Groundwater Application Review Summary Form

Application # G- 18778

To: Kristopher Byrd, Well Construction and Compliance Section Manager
From: Joel Jeffery, Well Construction Program Coordinator
Subject: Review of Water Right Application G-18778
Date: August 27, 2019

TO: Water Rights Section Date 8/15/19
 FROM: Groundwater Section Benjamin Scandella, Jen Woody
 Reviewer's Name
 SUBJECT: Application G-18778 Supersedes review of _____
 Date of Review(s) _____

Water Levels in Nearby Wells

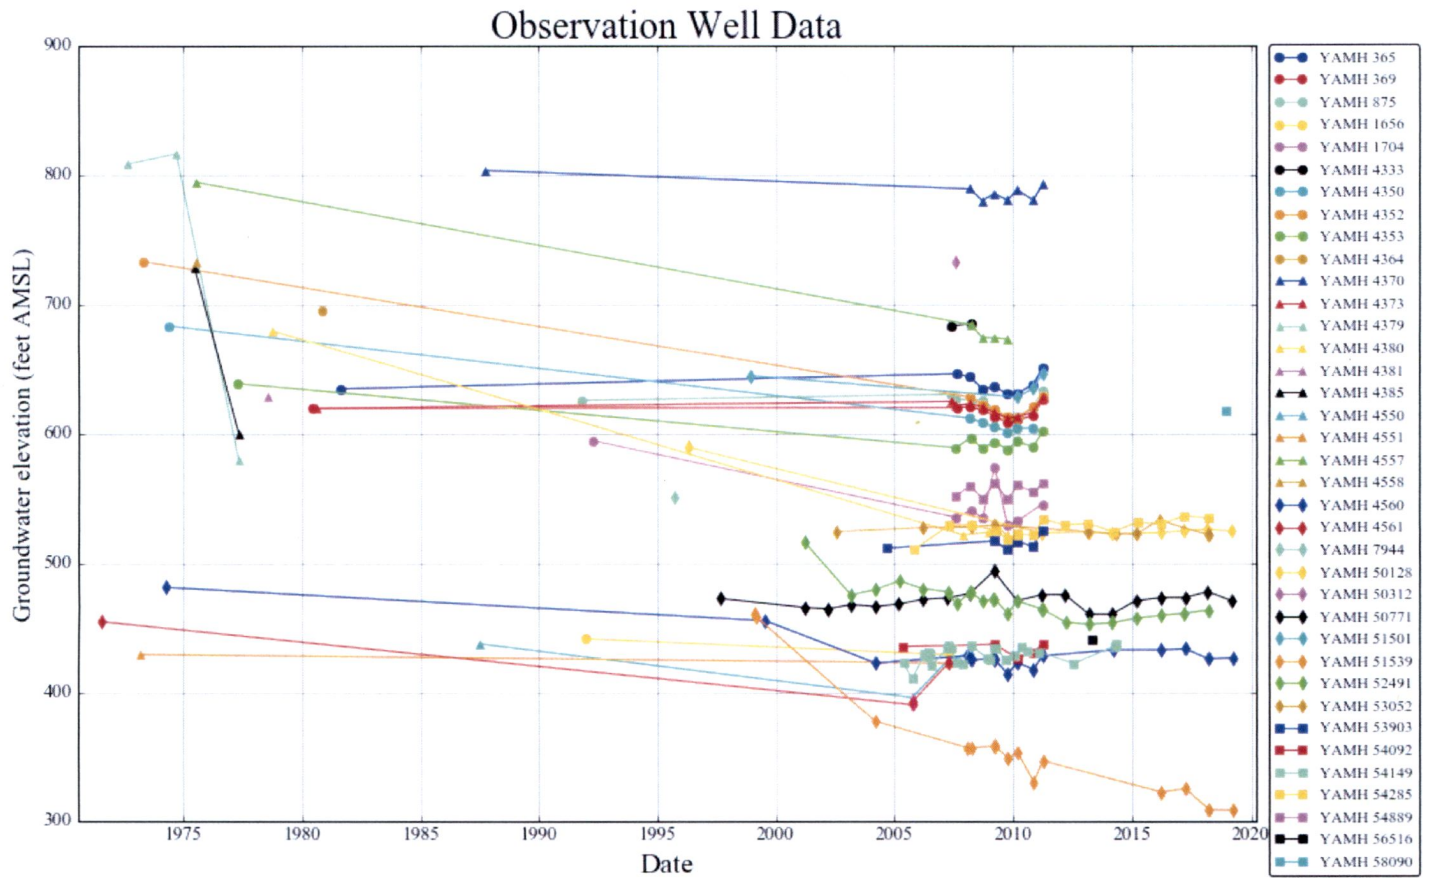
The proposed use of 11.5 acre-feet per year at a maximum rate of 30 gallons per minute (gpm) is unlikely to create drawdown interference with nearby wells that prevents access to water. Nearby wells access a variety of water-bearing zones within the CRBG aquifer system. Well logs in T3S/R3W- Sections 21, 22, 27 and 28 report yields ranging from 1 to 264 gpm, with a median yield of 15 gpm. Wells that access the upper elevation water-bearing zones show reasonably stable trends (see figure below), while wells that access the lower elevation water bearing zones show slightly more long-term decline. The subject well appears to access upper elevation water-bearing zones, with a water-level elevation of 618 ft above mean sea level according to the measurement on the well log from 12/19/2018. Water use and water level monitoring conditions are recommended to protect existing users.
